Amendments to the Drawings

REMARKS

Figure 3

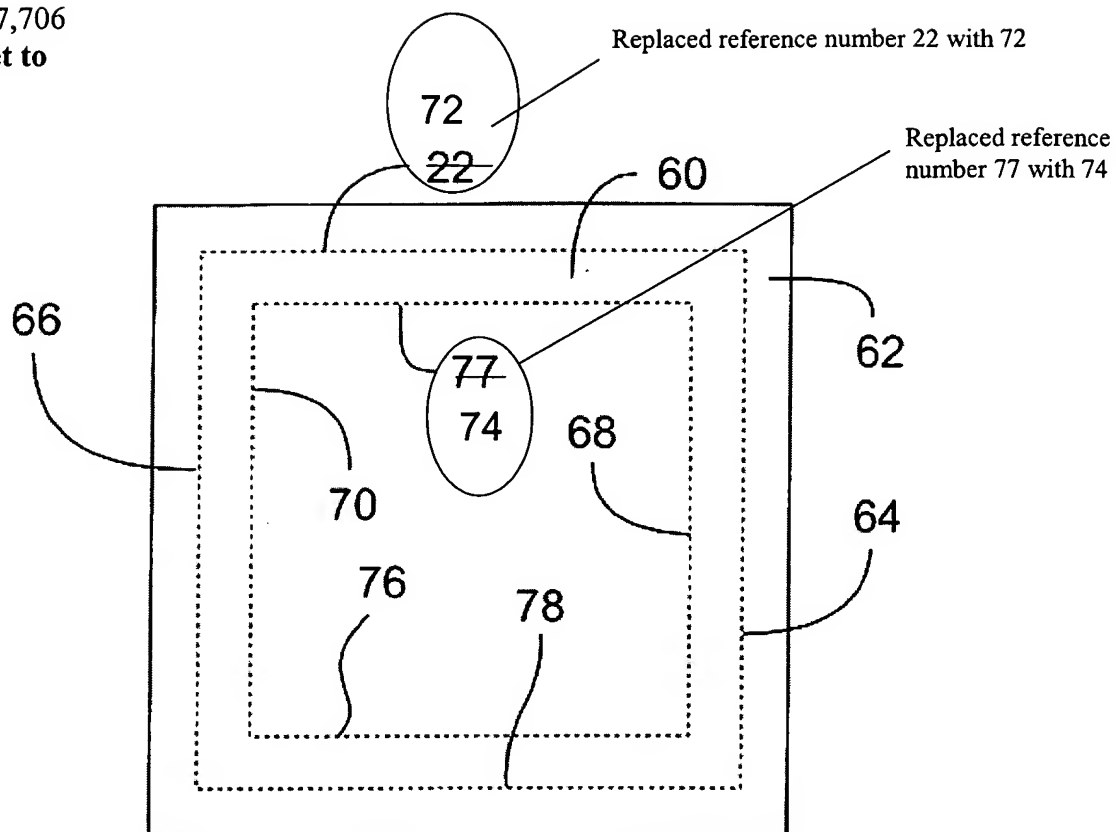
In amended Figure 3, the reference number 22 has been replaced with corrected reference numeral 72 and reference numeral 77 has been replaced with reference numeral 74.

Figure 4

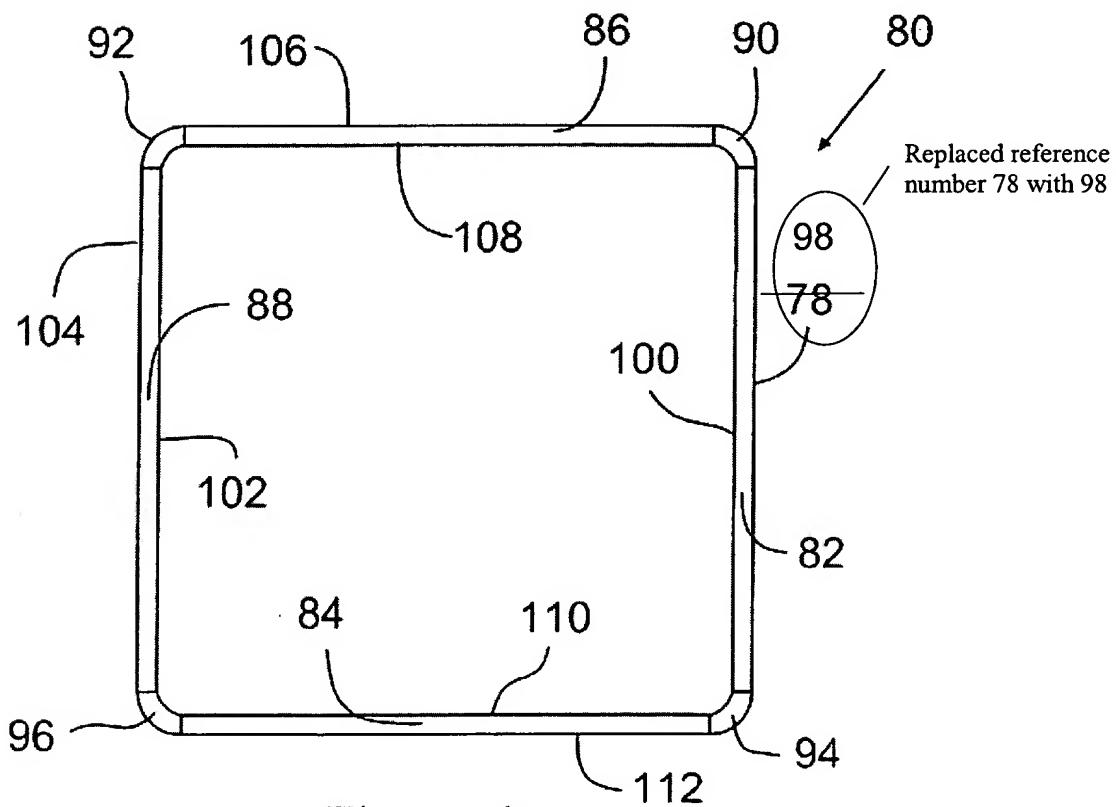
In amended Figure 4, the reference number 78 has been replaced with corrected reference numeral 98.
